INDESIT company

Model type:
BCB333AVEIFF

Commercial code:
F056497

Notices

0522067: SEALS FOR DOORS FOAMED AS ONE PIECE

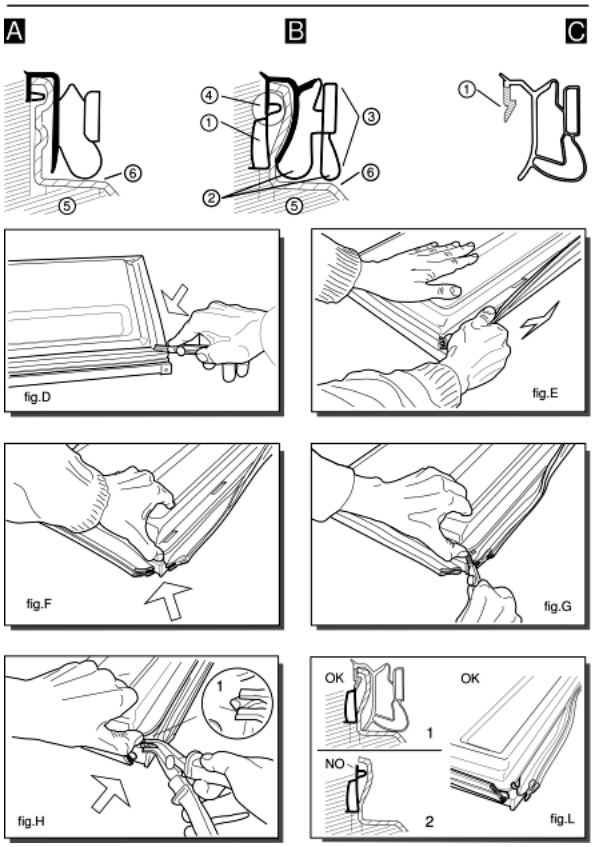
Various types of gaskets with different profile, as shown in figures (A) and (B), are used to fix the door (fig. A-5; B-5) and the inner door (fig. A-6; B-6) on the block foamed doors of combined freezers and refrigerators.
---Ilpea profile 245; 179; 412 (fig.A)
---Ilpea profile 287 (fig.B)
When replacing gaskets with profiles 245; 179; 412 these are fixed with screws (2 per corner) to the door.
Gaskets with profile 287 can not be used as spare parts but are designed to house the Ilpea type 900 gaskets (see figure C).
When replacing the gasket (287), once it is removed you will find a pocket (fig. B-1) between the door and inner door.
The rigid tooth (fig.C-1) of the gasket (900) is inserted inside between the pocket and the inner door, doing away with the need for screws.
Gasket with profile 287 is easy to identify since it has an exterior double edge (fig.B-2) which acts as a cushion when the door is closed.

To replace this gasket, follow these steps:
---Dismount the door and cut the four corners of the gasket along the joint (fig.D);
---lift the gasket and pull it carefully along its full length without tearing it (fig.E).
The purpose here is to detach the inner door slightly from the foam along the exterior edge for a depth equal to that of the gasket (fig.B-3);
---lift the corner of the inner door slightly, prising it up with your thumb (fig.F). Do not use a tool which might break the inner door;
---continue cutting the gasket inside the inner door for about 6 mm (fig.G);
---push in the tip of the pliers (type USAG N131) and pull outwards until you see the top edge of the pocket (fig. B-4) which is empty (fig.H-1);
---if you carry out this operation correctly (fig.L) you will be able to pull off the top edge of the pocket for the full length of the door.
If the gasket tears before the top edge (fig. L-2) you should repeat this operation from the other corner of the door.

---once the gasket (287), has been removed the space above the pocket (fig. L-1) can house the rigid tooth (fig. C-1) of the gasket 900.
When you fit this gasket ensure that it lies flush against the edge for the full length of the door.
If the rigid tooth is difficult to fit, eliminate any residues of foam between the door and the inner door in the gasket area.
fig.5131549A
